Check Sheet

Company Name: Champion Int'l Corp  
Permit Number: AC 17-1420004  
PSD Number:  
County: Escombia  
Permit Engineer:  
Others involved:

1. 30"x42" BLUEPRINT:  
ENGINEERING FLOW  
DIAGRAM INC. G SYSTEM  
BLOW HEAT RECOVERY  
MODIF. PENSACOLA MILL
2. 30"x42" BLUEPRINT:  
NCG COLLECTION AND  
INCINERATION PROCESS  
AND INSTRUMENTATION  
DIAGRAM

RE: DER File No. AC17-142004

Figure 1

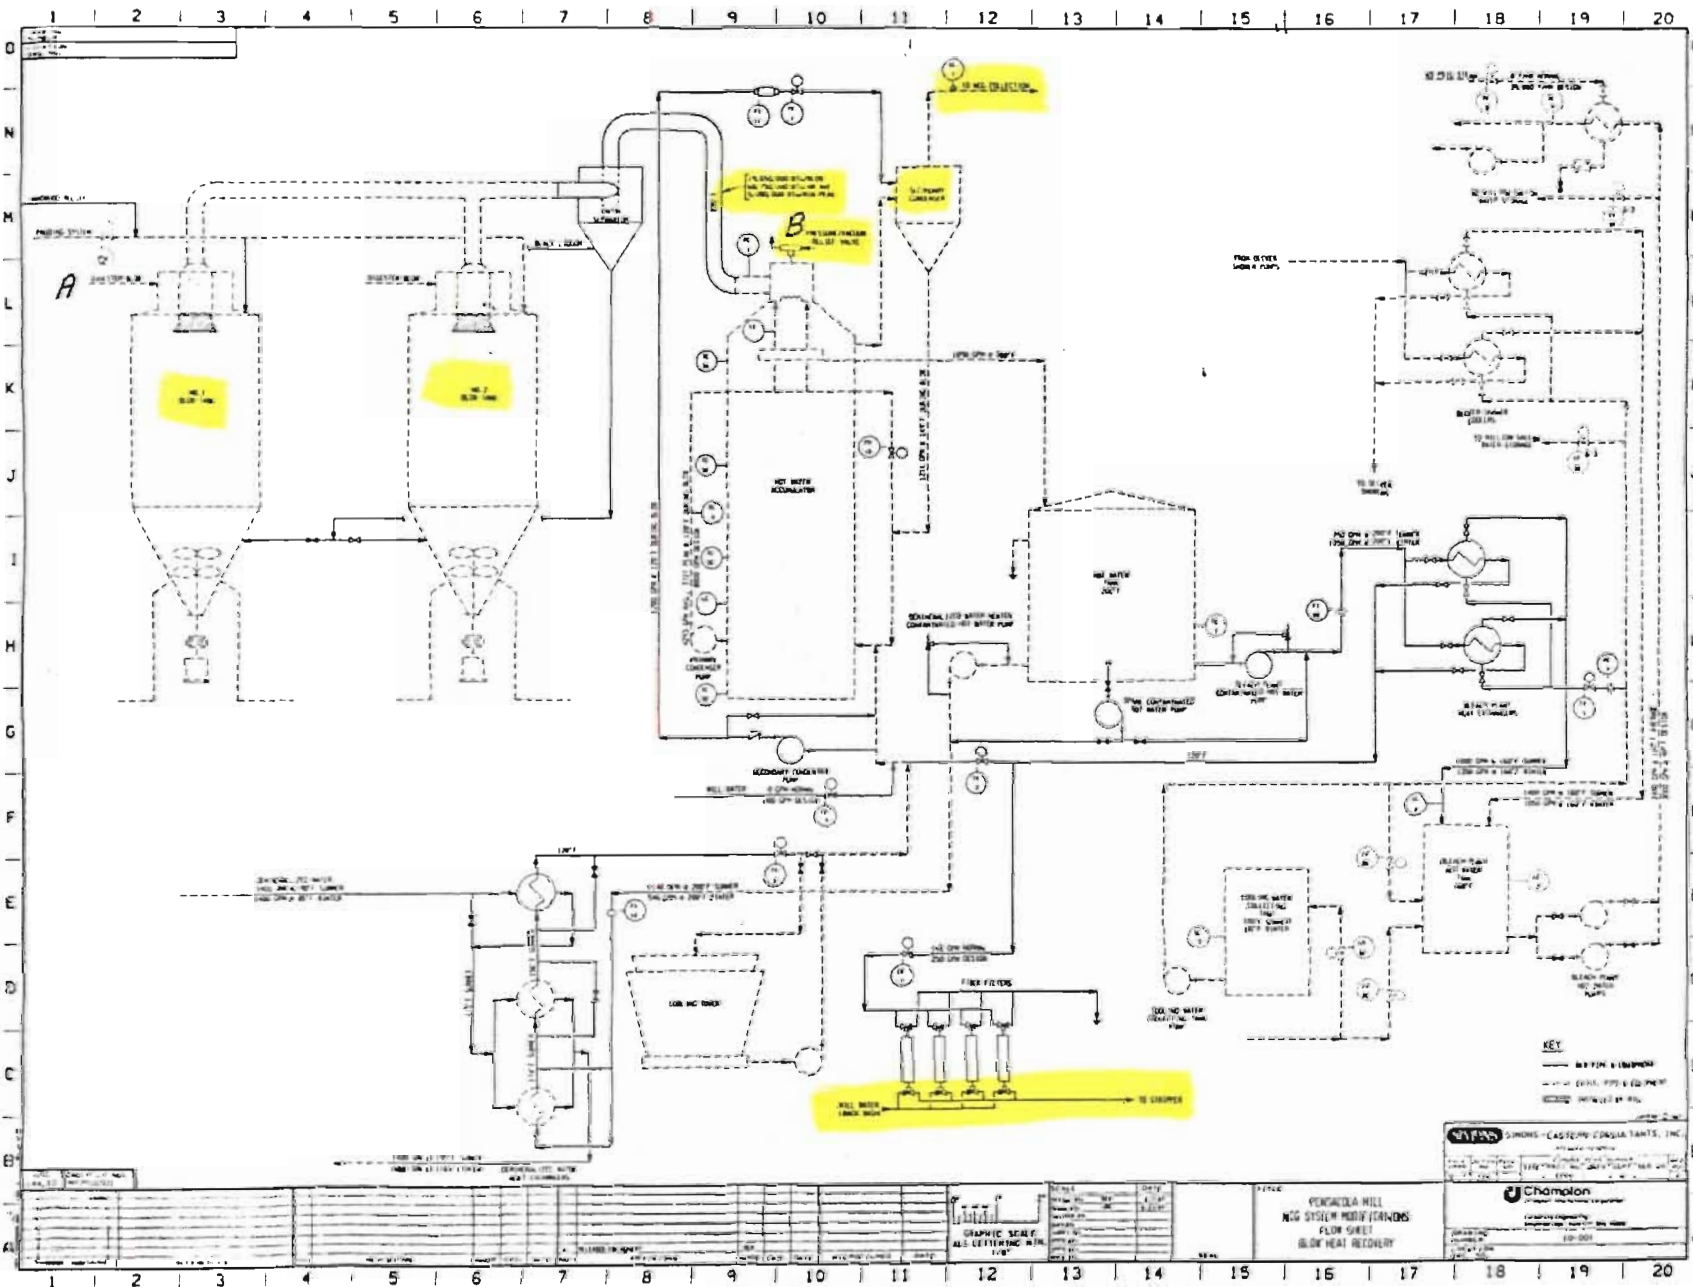
*Will  
Karr  
blow tank  
be controlled*

Figure 4

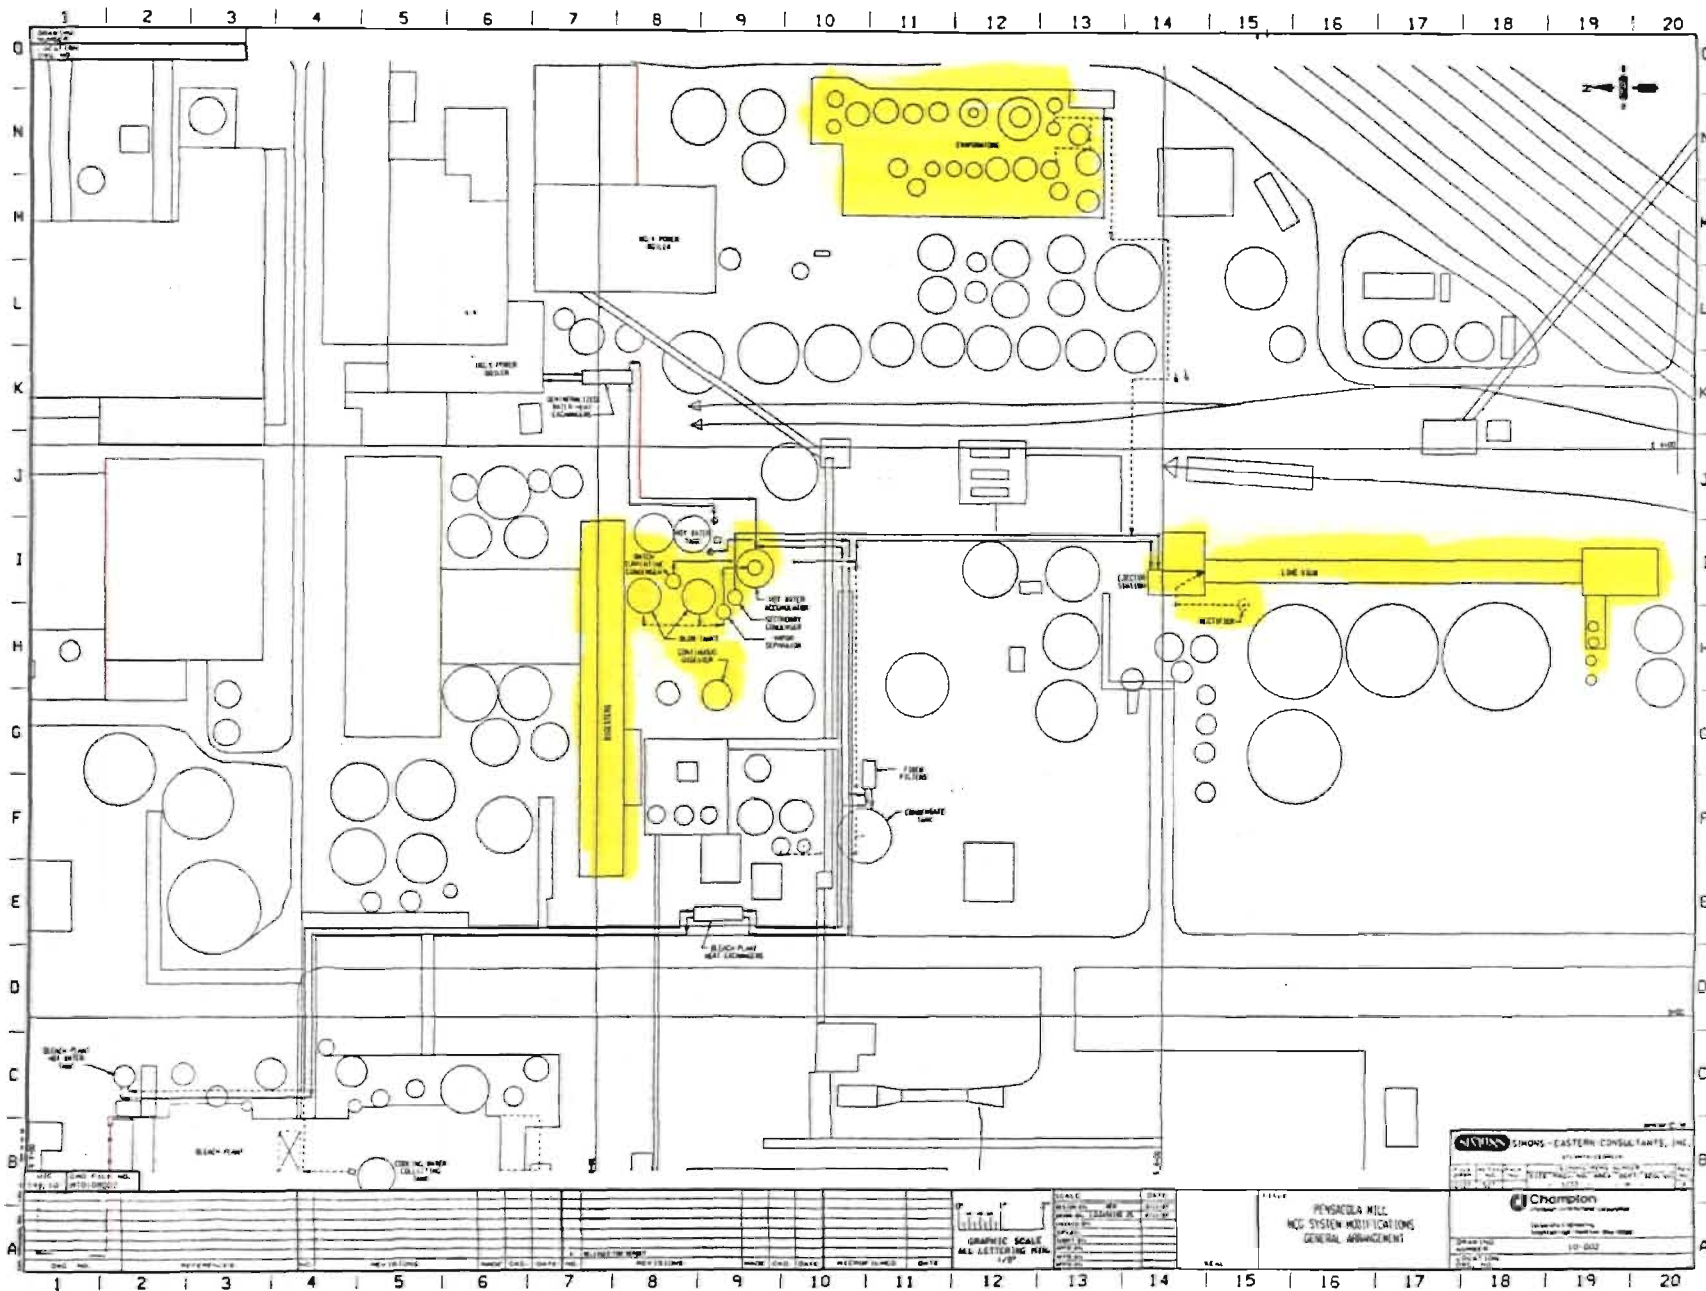
ADD 1, Identify an emission point at the affected sources that will remain uncontrolled & explain why.
